Addendum 02

Project #: 1328-23

MAISD South – Office Renovations
684 Harvey Street
Muskegon, MI 49442

Purpose: Addendum 02

PLUMBING PLAN
SCALE: 1/8"=1'-0"

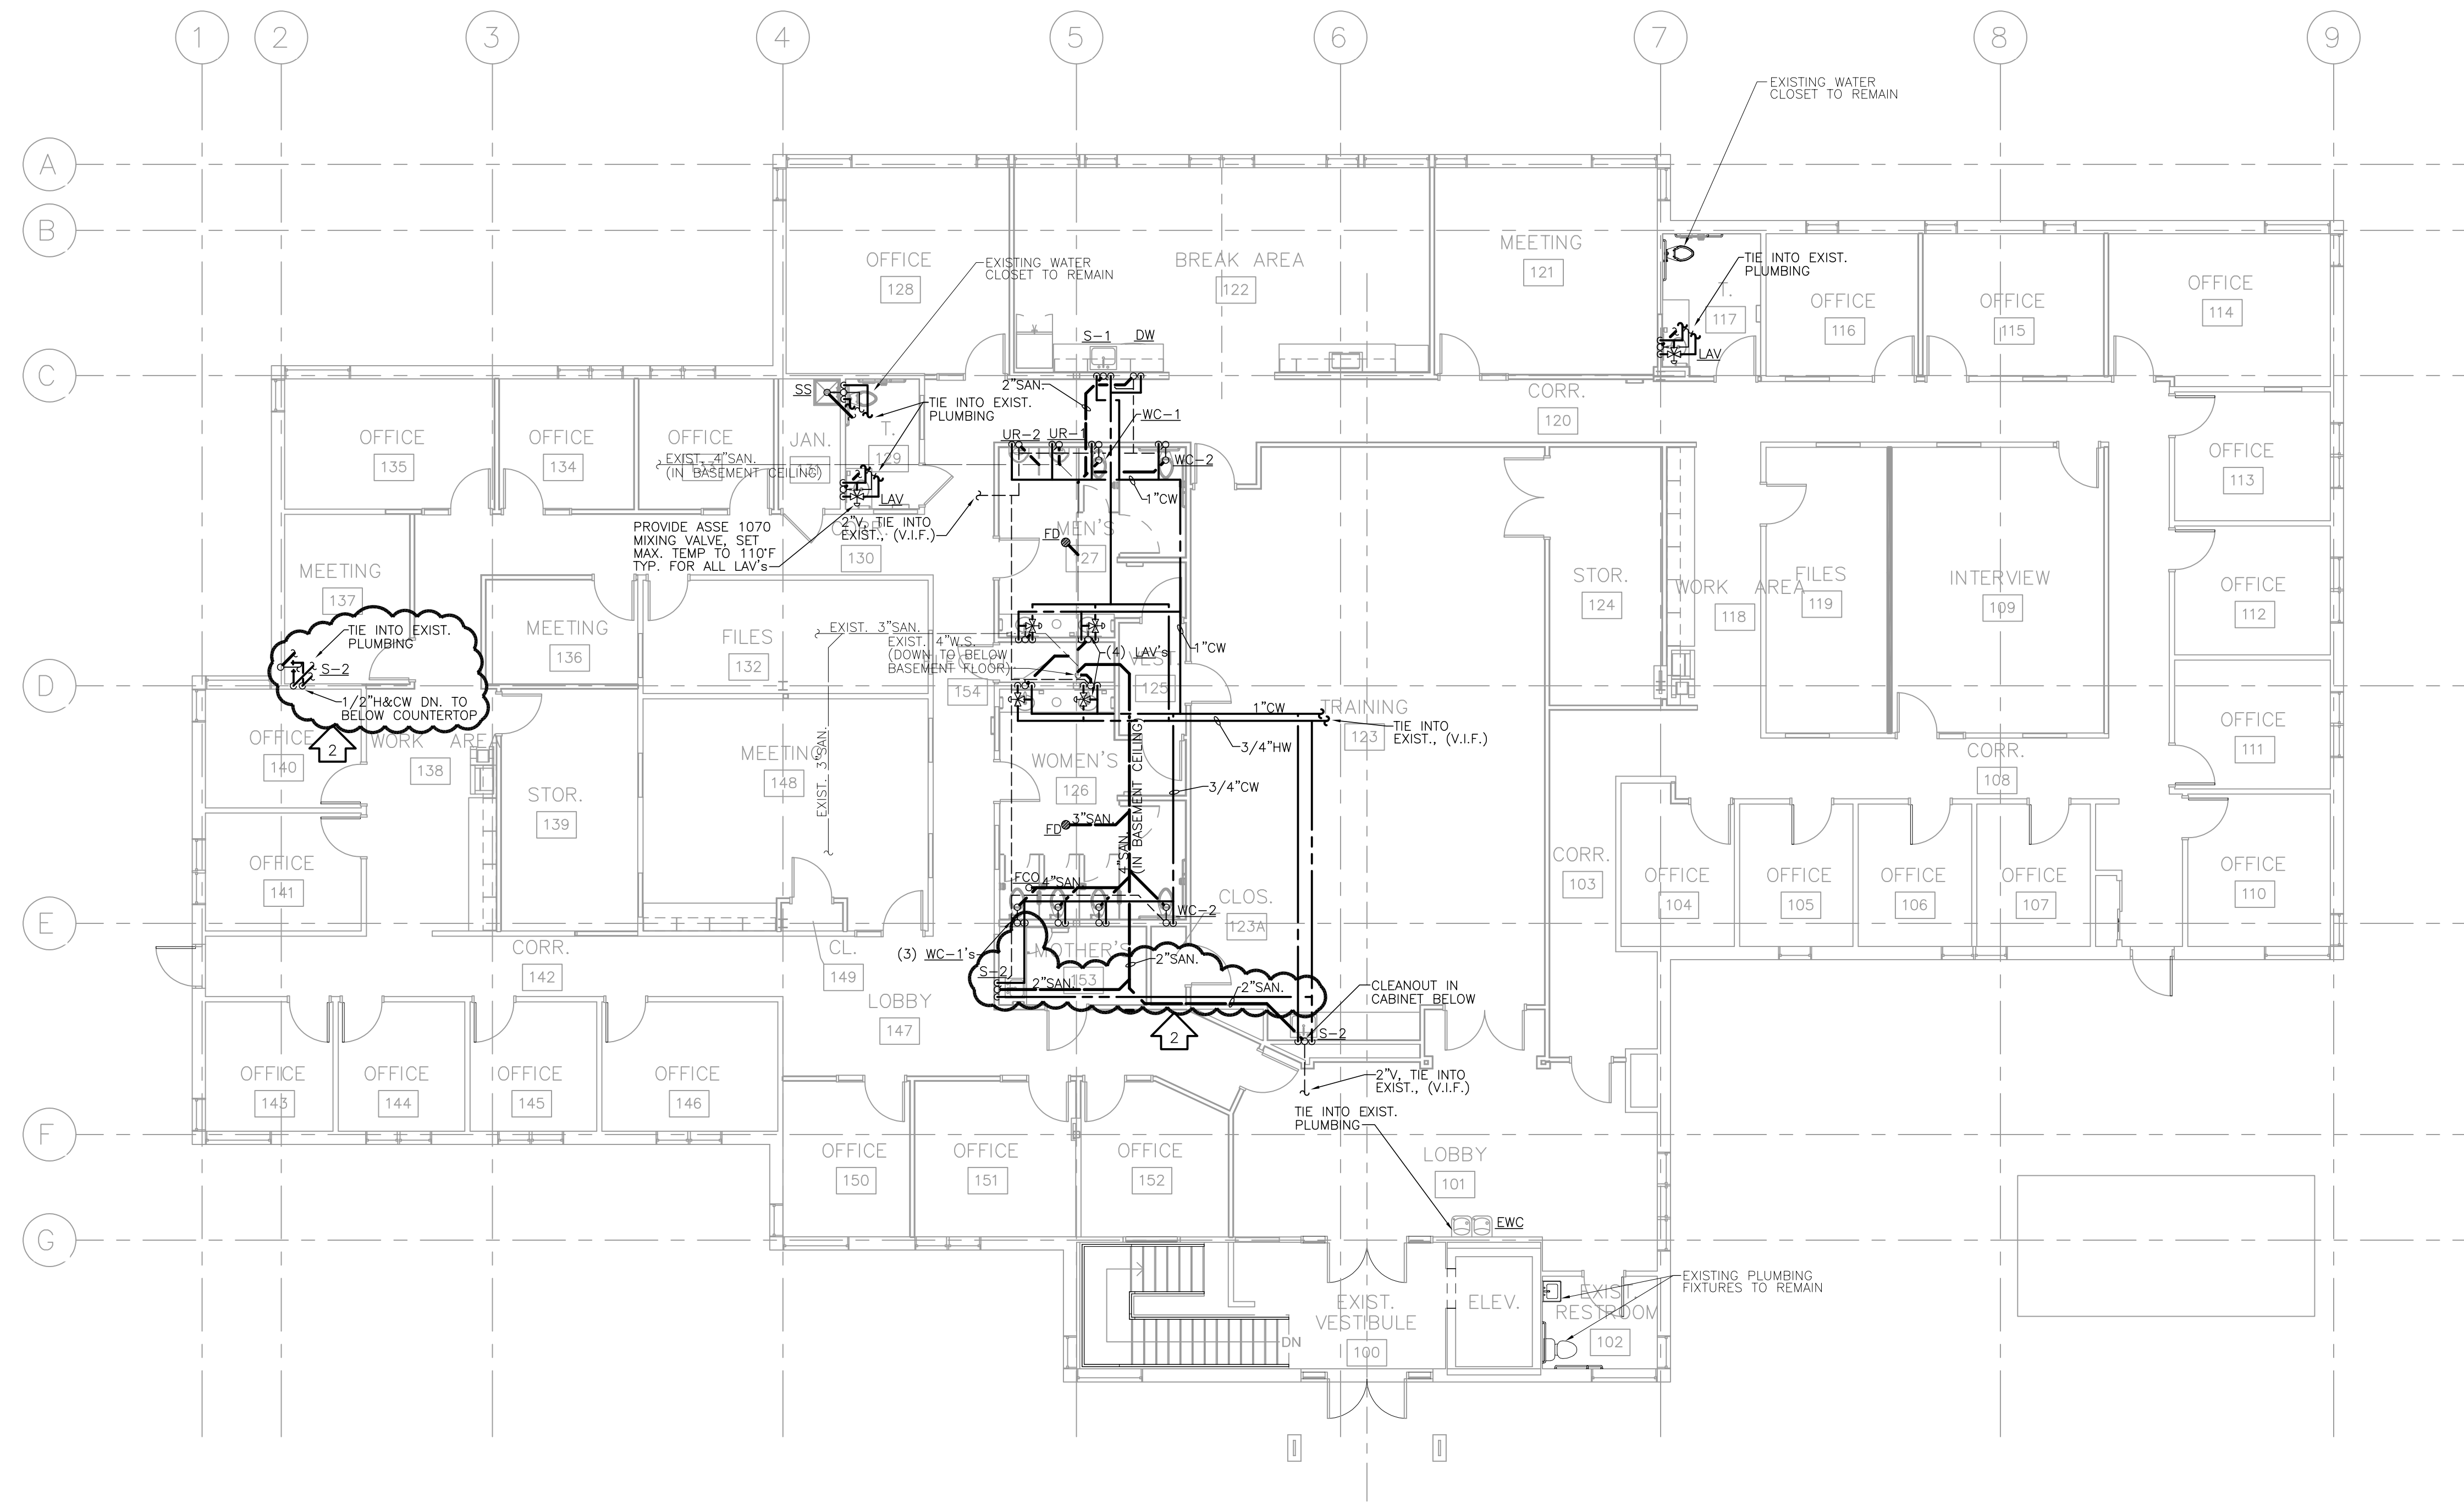
Item #3 Mother’s Room 137 Relocation :

See attached revised drawings. Mother’s Room 137 to be relocated to former Closet 153. New cabinetry and sink to move to West wall of former closet. 15” drawer base added. Former Mother’s room to become a Meeting room.
Create new Closet 123C. See door and finish schedules.
Revise door hardware: Door 153 – Set 05, Door 137 – Set 10. Add new 30 x 70 door at new Closet 123A. Door 123C – Set 13.
Revise Plumbing for new sink and abandon piping from old sink in 153.
Revise lighting as follows: Meeting 137 to get (2) ‘B’ fixtures with occupancy sensor switch, Mothers 153 to get (2) ‘C’ fixtures with Dimmer switch.
Revise Power as follows: Meeting 137 – provide (3) outlets and (1) data drop(East wall), Mothers 153 – Provide outlet for undercounter refrig and (1) GFI outlet above counter(42”) with one additional outlet at east wall.
